HOWARD COUNTY HEALTH DEPARTMENT

Payne Tract

RE: Payne property; 3 lots
Watersville Road area

PLAT TO
ACCOMPANY
VARIANCE APPLICATION
VP-77-92

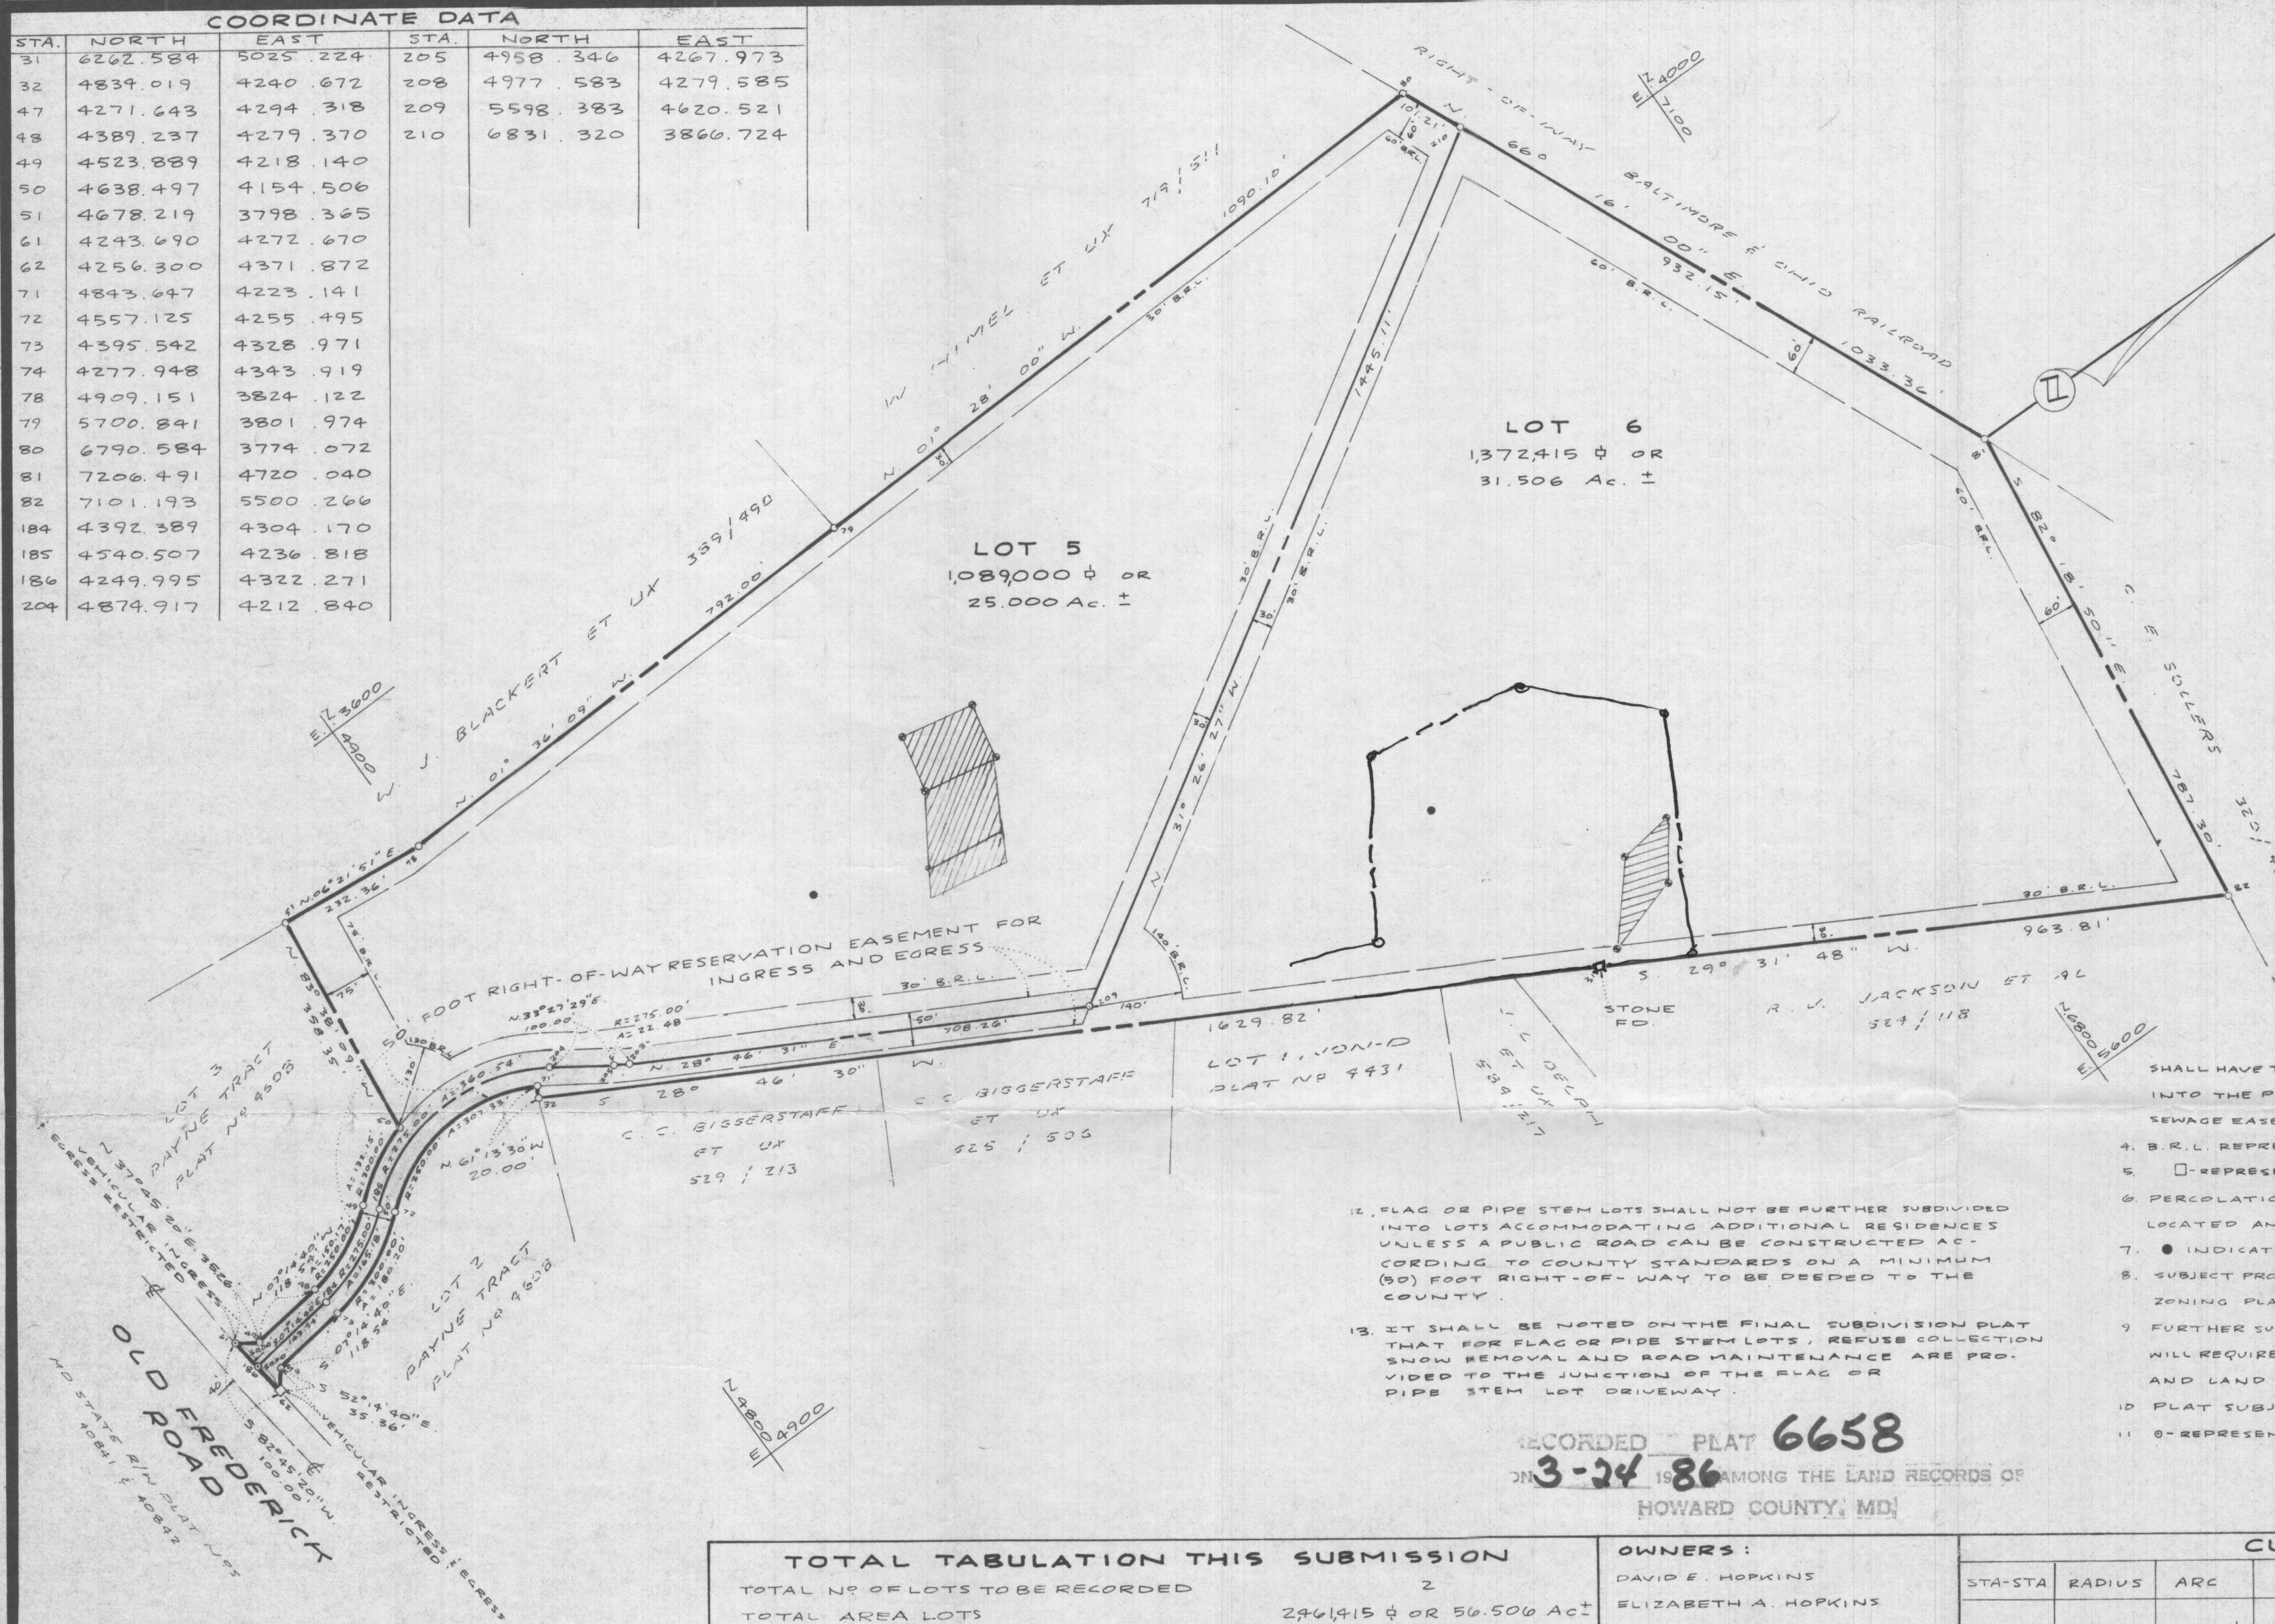
- (1) Sewage easement statement in total.
- (2) Minimum ownership clause needed
- (3) Lots #1 + #2 are not approved all holes are not shown.
- (4) Call after J. Stayer reviews + Returns C.B.D.

(5) J. Stayer agrees his #3 not shown correctly.

Please be advised that the Health Department, after calling for revisions of percolation areas on present platt, still is awaiting an updated platt with more complete and accurate information.
